Regulatory Oversight Report for Uranium Mines, Mills, Historic and Decommissioned Sites in Canada: 2017

Commission Meeting
December 12, 2018
CMD 18-M48.A

CNSC Staff Presentation

Operating Facilities – Radiation Protection Performance Total Collective Dose (p-mSv) – 5-Year Trend

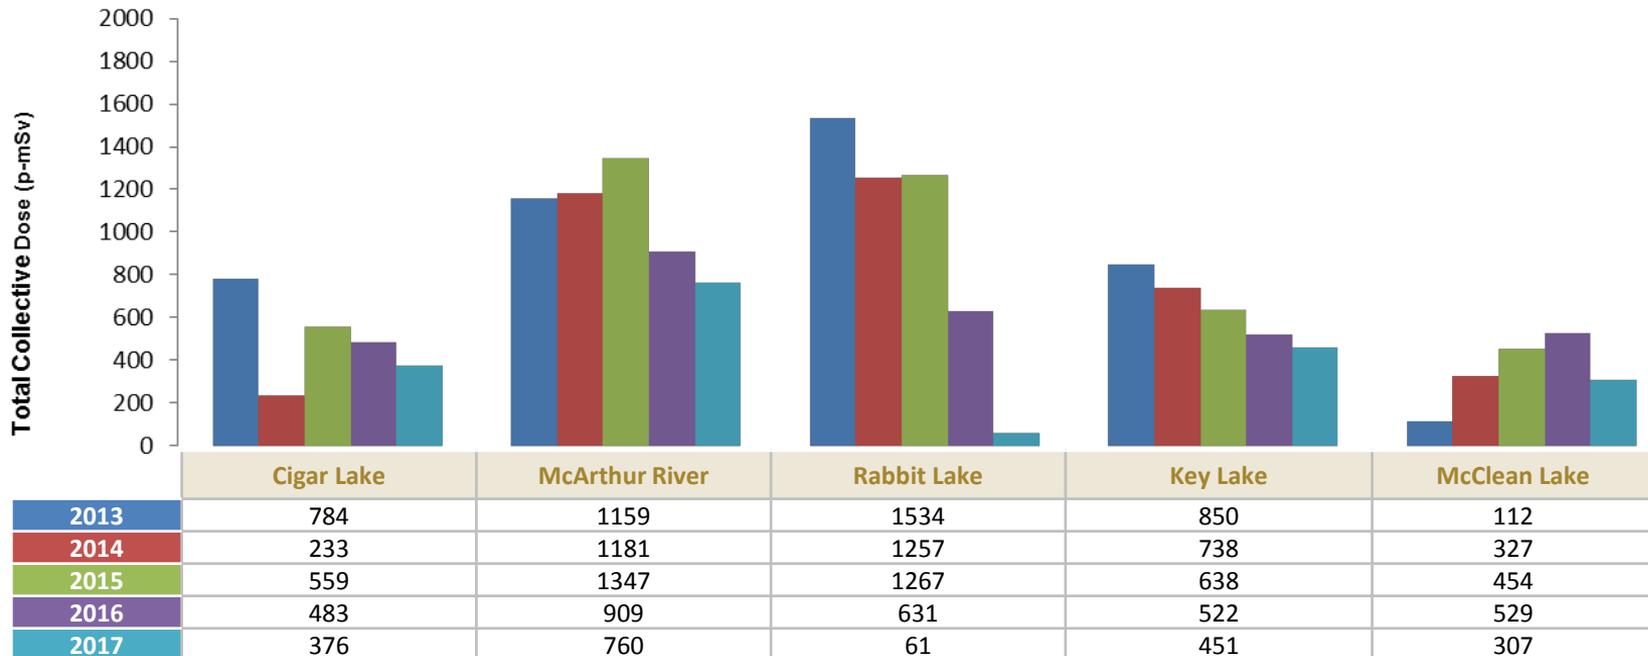
Errata – Page 41, CMD 18-M48

- Figure 3.3, bar chart for collective dose totals in 2013 and 2014 do not correctly display data
